QUALITY ASSURANCE -- NON-CONFORMANCE REPORT

Report No: NCR-000791

Welding	Concrete	Other	
Welding	Curing	Procedural	Bridge No: 34-0006
Joint fit-up	Coating	Other	Component: Lift 4 Strut (ND1-STSA4-6-127M-1)
Procedural	Procedural	Description:

Reference Description: Lift 4 Strut (ND1-STSA4-6-127M-1): Missed UT Indication

Component: Lift 4 Strut (ND1-STSA4-6-127M-1)

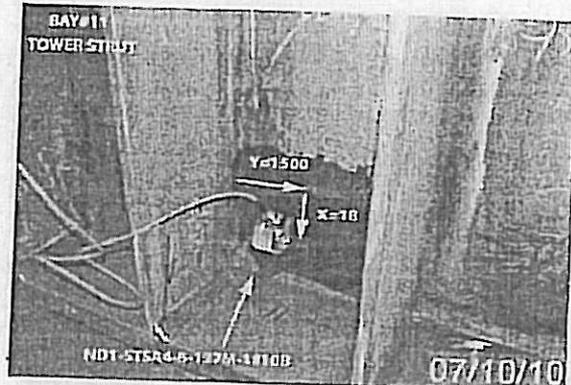
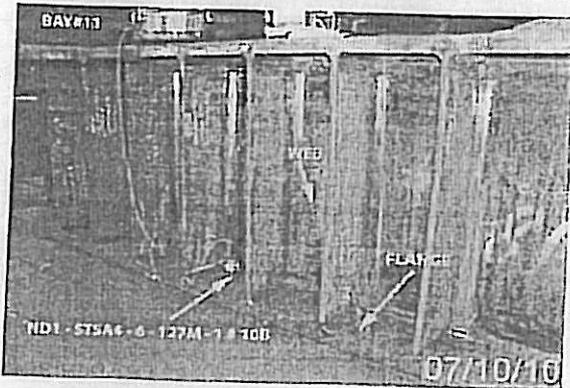
During random 10% verification Ultrasonic Testing (UT) of Tower Strut, Quality Assurance Inspector (QA) discovered the following issues:

One (1) Class "A" non conforming longitudinal indication measuring approximately 15 mm in length. The weld is a complete joint penetration (CJP) corner joint, joining Web to Flange and is identified as ND1-STSA4-6-127M-1.

The discontinuity rating is +9, Class "A" and reject.

Depth of the discontinuity from face B is approximately 15 mm, and Y location was 1500mm.

WELD NUMBER: ND1-STSA4-6-127M-1-10A/B

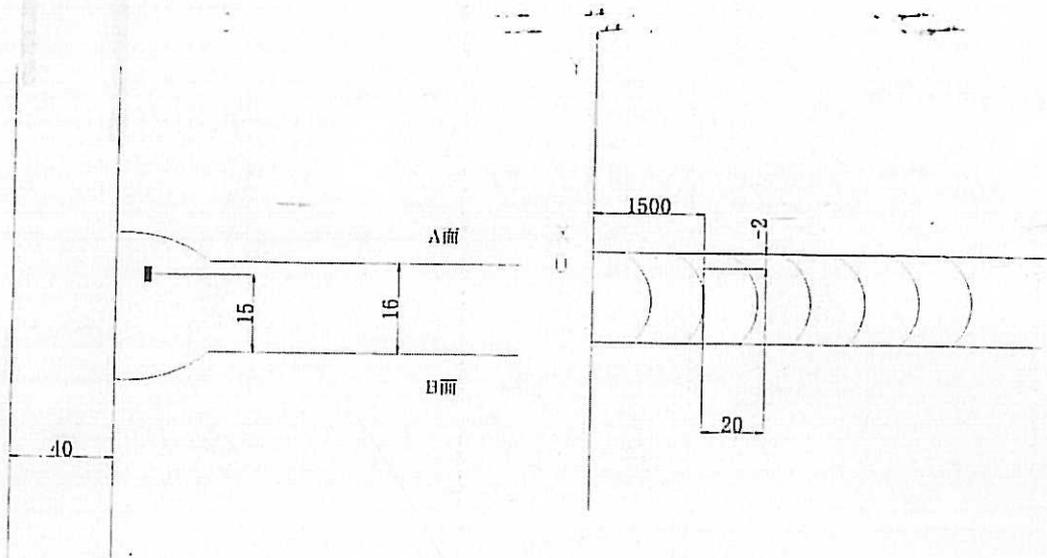
Rejected indication found by ultrasonic inspection is less than the maximum allowance aggregate length.

(UT探伤发现的缺陷总长度小于最大允许长度) ND1-STSA4-6-127M-1-10A/B

- 1、 碳刨后,焊接接头没有有效打磨;
 - 2、 起弧和收弧没有交错布置,以将焊渣减少到最少;
 - 3、 焊道间没有有效的清理.
- 1.The weld joint was not ground sufficiently after arc-gouging.
 2. The arc starts and stops were not staggered to minimize slag entrapment.
 3. Interpass cleaning was not performed properly.

- 1、碳刨后的接头位置打磨圆滑过渡，保证每道焊缝的接头可以交错布置；
 - 2、认真仔细检查每道焊缝和加强焊道的清理；
 - 3、焊缝中所有的焊渣全部去除后，表面的缺陷全部打磨干净。
1. The joint shall be ground to a smooth transition to ensure that arc starts and stops are in a staggered Arrangement.
 2. QC shall inspect the weld passes more carefully and enforcing interpass cleaning.
 3. All weld slag shall be removed and surface defects ground during interpass cleaning.
